PLANNING & ZONING COMMISSION

Wednesday, December 9, 2015

1. SKETCH PLAN REVIEW

Applicant: Pulte Homes
 Location: 8213 Steitz Road
 Existing Zoning: Liberty Township, Farm Residential District (FR-1)
 Proposed Zoning: City of Powell, PR, Planned Residential District
 Request: To review a sketch plan for a proposed subdivision consisting of approximately 128 units on roughly 70 acres.

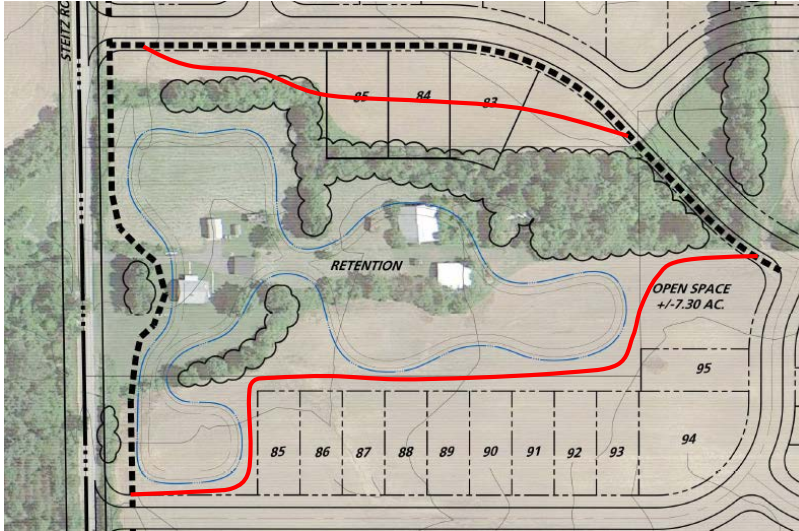
1. Remove lots 83, 84, and 85 from the northern main entrance road. This would increase the amount of open space and takes out lots that seem out of place. Furthermore, it would reduce the density of the project from 1.81 du/ac (dwelling units per acre) to 1.77 du/ac, which is more in line with the 1.7 du/ac maximum that staff feels is appropriate for this area of the city.

2. Have the multi-use paths go through the above open space area instead of at the edges. This would provide a loop trail that residents could use. Also, it improves safety, by taking the trail from the along the road to an interior space. Essentially, separating the pedestrian from the vehicle.

3. Consider connecting the two north east cul-de-sacs in order to create a loop street. This option has both positives and negatives that will need to be discussed at the next meeting. For instance, one positive is that by removing the dead-end streets, traffic flow is improved and reduces conflict points. This allows for better access for school buses, trash trucks, emergency vehicles, etc. A negative is more roadway and higher maintenance cost to the city, and less interconnectedness of open space. Staff defers to P&Z for direction.

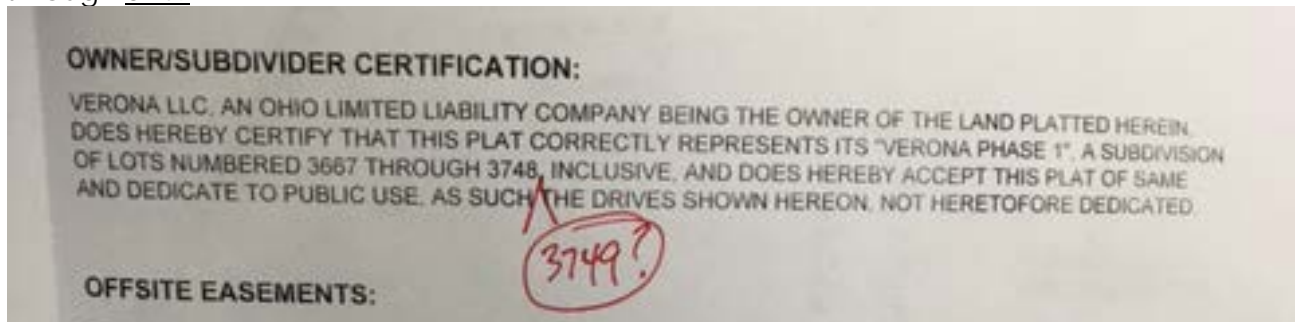
1. The fourth paragraph in the notes section on page 1 should actually read: First floor elevations shall not be altered without Powell building and Engineering department approval.
2. The notes section requires language for ownership and maintenance responsibility for open space lots 3696, 3697, 3748, and 3749.

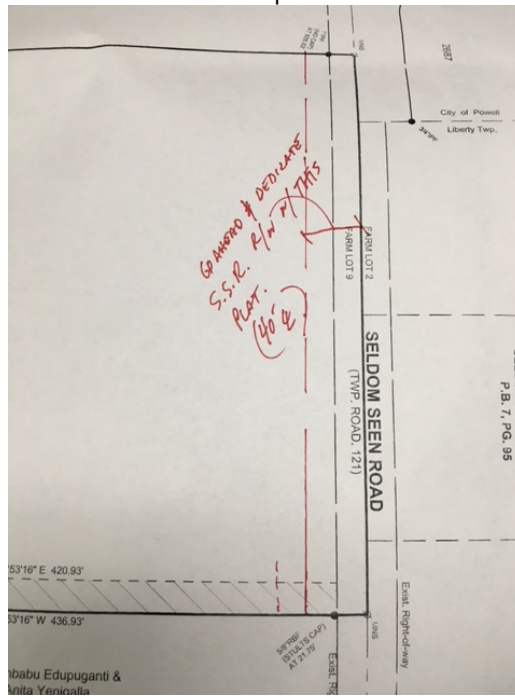
3. Under the Owner/Subdivider Certification section, it should read: ...lots numbered 3667 through 3749...

4. On sheet 4, the Seldom Seen Road right of way (ROW) should be dedicated with this plat. As a result, the applicant should draw onto the plat the 40 foot ROW.
